Optimum 40GBase-CR4 Lane Assignment

Ali Ghiasi
Broadcom Corporation
aghiasi@broadcom.com

- **Response to comment 872**
- **Classic QSFP pin out carried forward in 802.3ba is not optimized if lane orders must be maintained**
 - **Clause 85 requires maintaining connecting lanes to MDI contact per definition of table 85-12 because of training requirements**
 - **On other hand Clause 86 allow any lane to MDI contact connection**
- **With single routing layer one could connect host ASIC to 40GBase-SR4 MDI but the requirement of CL85 require to use 3 precious routing layers**
 - **This will force use of more expensive board with blind vias**
- **The conflicting requirements of CL85 and 86 could also result in incompatible systems**

Current QSFP Pinout

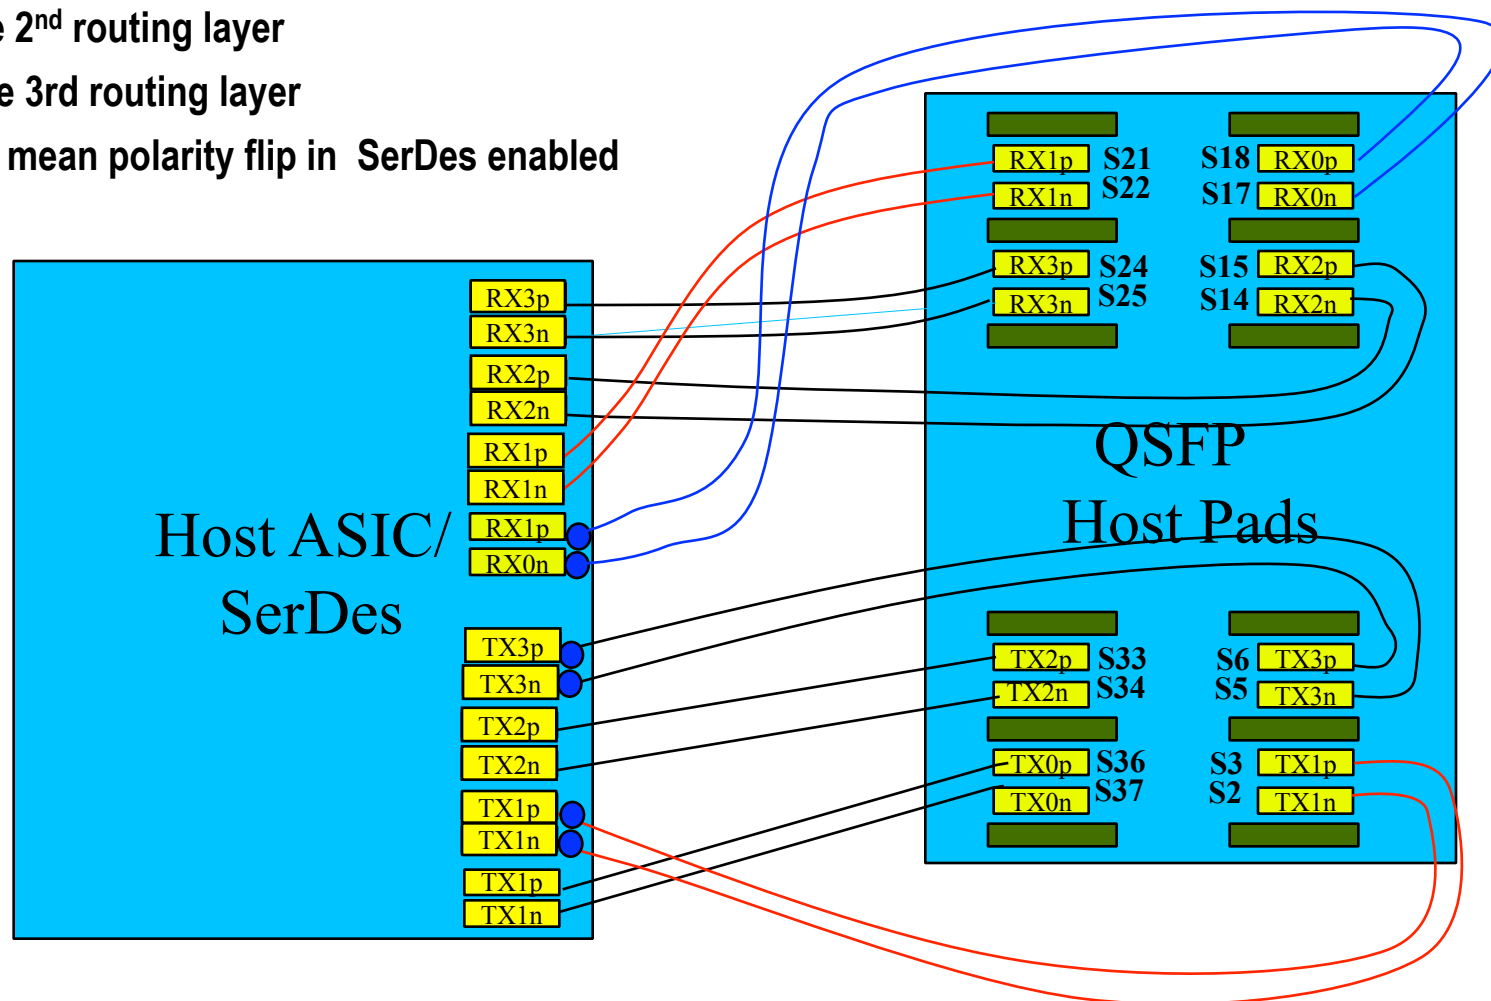
- QSFP pin out is not optimized and require 3 routing channel
 - Red is the 2nd routing layer
 - Blue is the 3rd routing layer
 - Blue dots mean polarity flip in SerDes enabled

Optimized QSFP Pinout

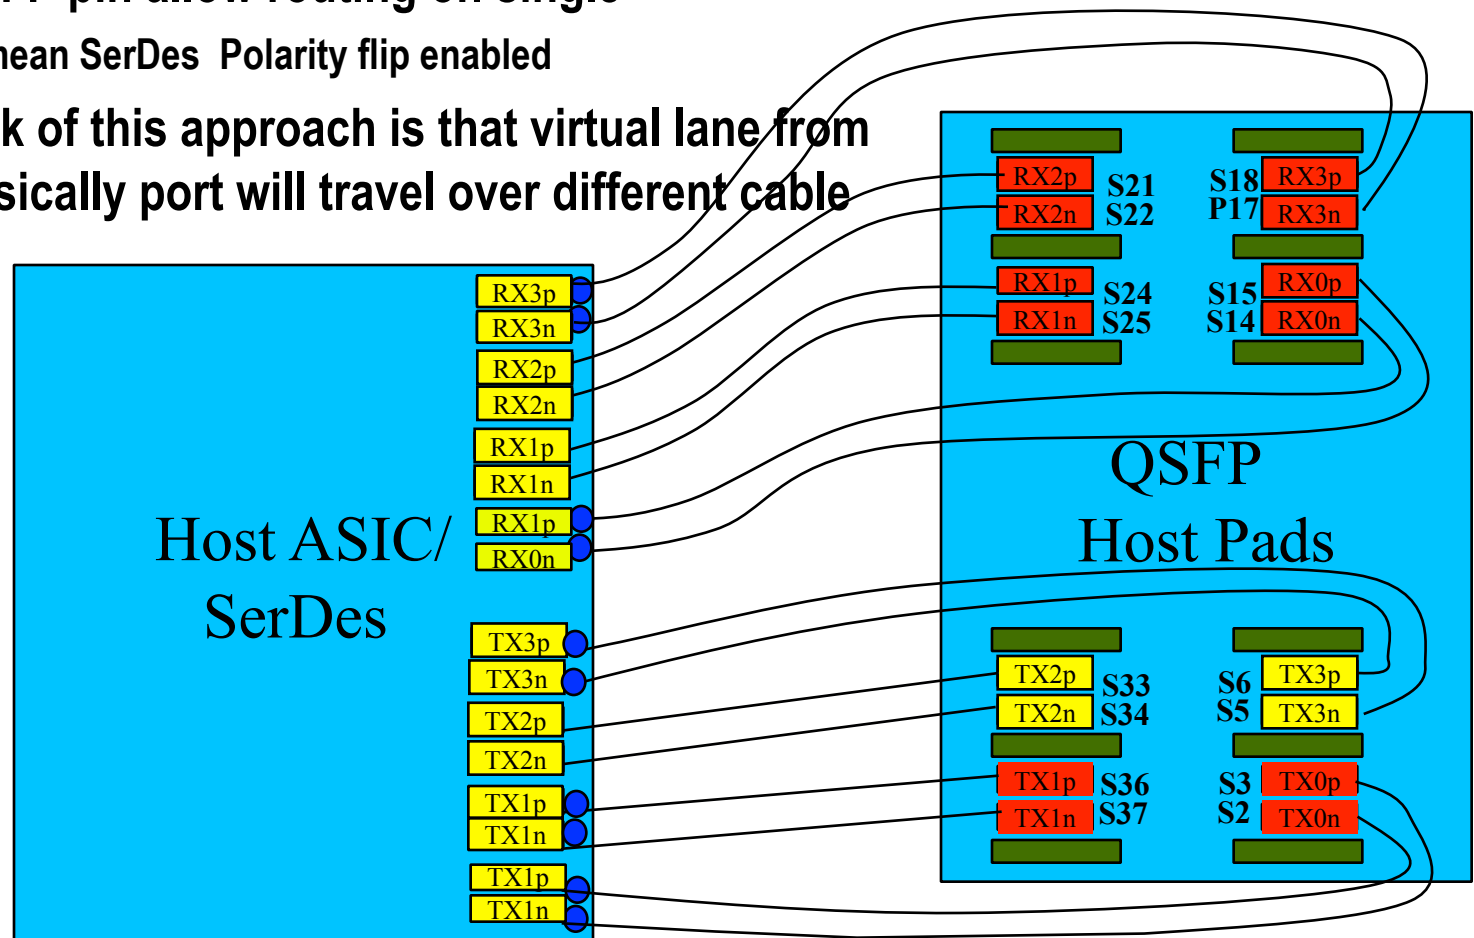
- Optimized QSFP pin allow routing on single
 - Blue dots mean SerDes Polarity flip enabled
- One draw back of this approach is that virtual lane from the same physically port will travel over different cable pairs

* Red pads on QSFP means contact was reassigned

Example Host Levering MLD Flexibility

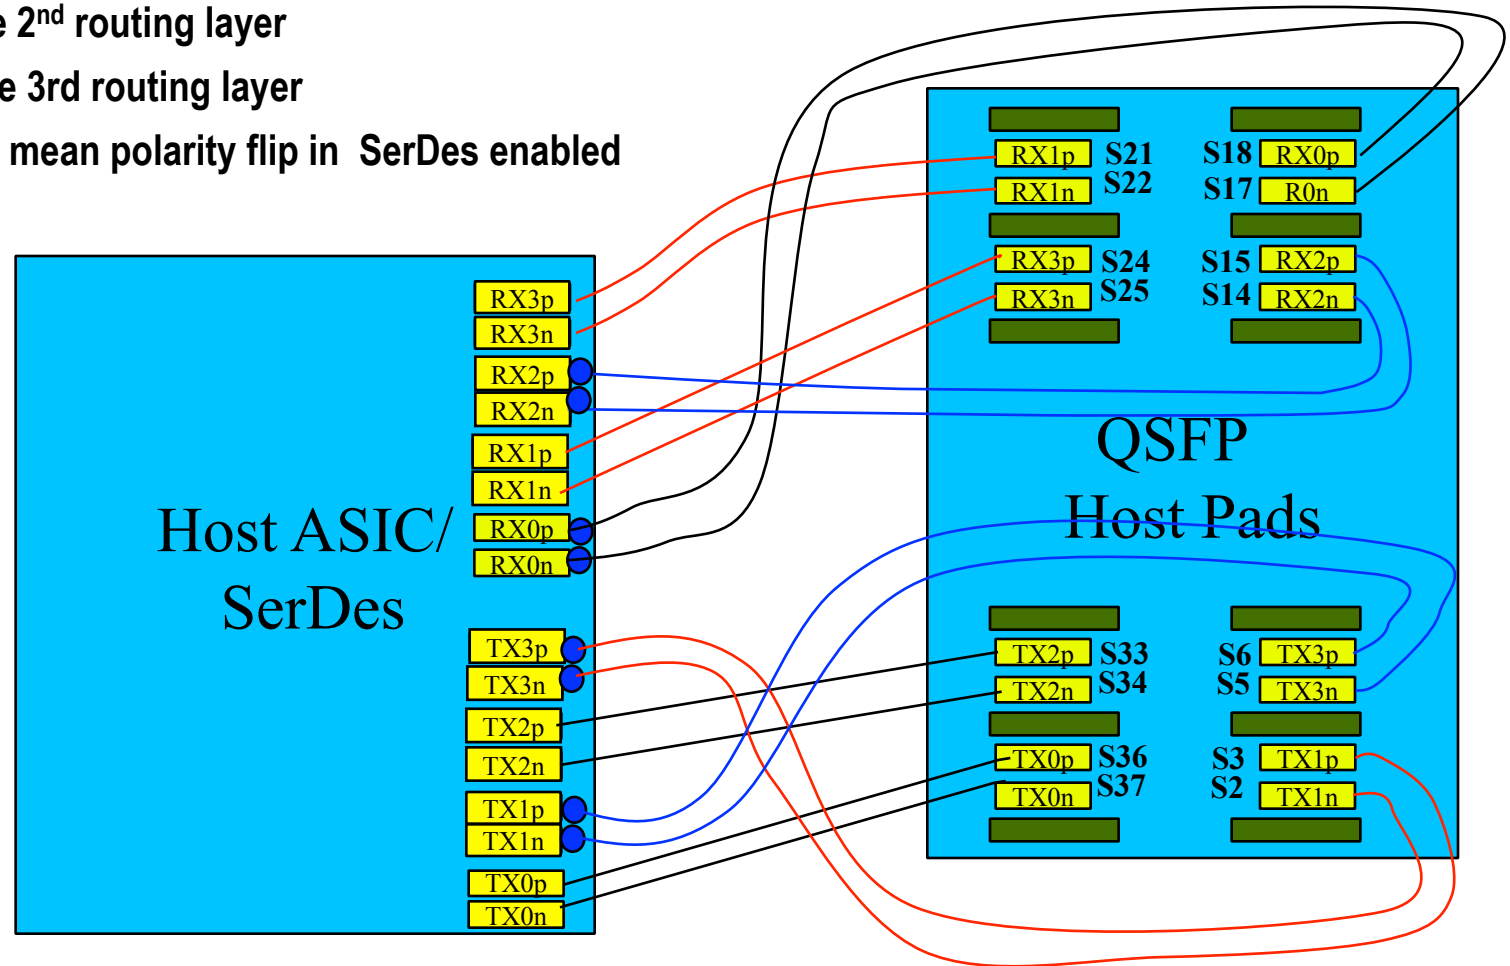
- In this example TX2/RX2<n,p> where swapped with TX4/RX4<n,p>
 - Red is the 2nd routing layer
 - Blue is the 3rd routing layer
 - Blue dots mean polarity flip in SerDes enabled
